<b>Delegated Report</b>		<b>Analysis sheet</b>	<b>Expiry Date:</b>	<b>01/10/2020</b>
		N/A	<b>Consultation Expiry Date:</b>	<b>05/09/2020</b>
<b>Officer</b>			<b>Application Number(s)</b>	
David Peres Da Costa			2020/2936/P	
<b>Application Address</b>			<b>Drawing Numbers</b>	
23 Ravenshaw Street London NW6 1NP			Refer to draft decision notice	
<b>PO 3/4</b>	<b>Area Team Signature</b>	<b>C&amp;UD</b>	<b>Authorised Officer Signature</b>	
<b>Proposal(s)</b>				
Erection of a three storey plus basement building comprising 7 Class C3 flats (4 x 3-bed units and 3 x 2-bed units) with balconies at rear following the demolition of the existing house.				
<b>Recommendation(s):</b>		Refuse planning permission		
<b>Application Type:</b>		Full planning permission

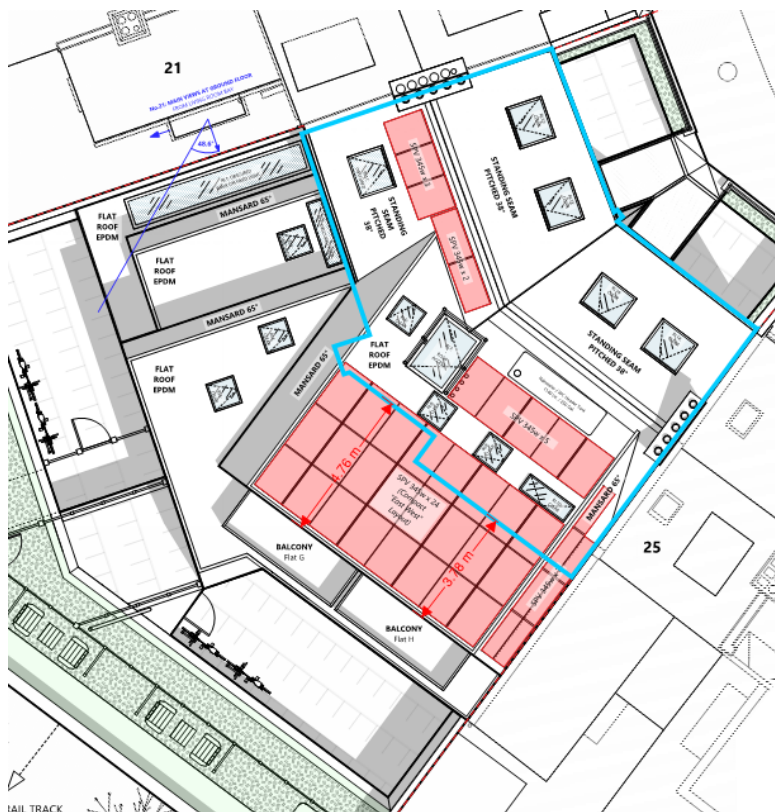
- 2.27. A comparison of the first floor of the appeal scheme and the current application demonstrates that the overall dimensions are very similar. The plan shown below is the appeal scheme with the outline of the current application laid over the top (as shown by the blue line)

- 2.28. A comparison of the second floor of the appeal scheme and the current application shows that the second floor of the current application has been significantly pulled back from the depth of the second floor sought at appeal. The plan shown below is the appeal scheme with the outline of the current application laid over the top (as shown by the blue line)

- 2.29. While the size of the second floor has been reduced, the design draws on oversized dormers in this street and neighbouring streets as a precedent. This results in the proposed southern dormers appearing disproportionately large.
- 2.30. The inspector for the previous appeal made the following observation:
- 2.31. *Regarding the proposed rear elevation to the property, the scale, mass and overall width and depth of the block would be excessive and significantly at odds with the surrounding*

- 2.32. While the mass has been reduced at second floor level, the inspector's concerns in relation to scale, mass and overall width are still relevant. Officers consider that the rear of the development would still appear disproportionately large and out of keeping with the rear of the terrace. Although the scale and mass would not be visible from the streetscene, it would be apparent from the private realm of rear gardens in the street, and in private views from flats in Ellerton Tower on Mill Lane and from flats in the Brassey Road Estate to the south of the railway. It would also be visible from the railway line to the rear.
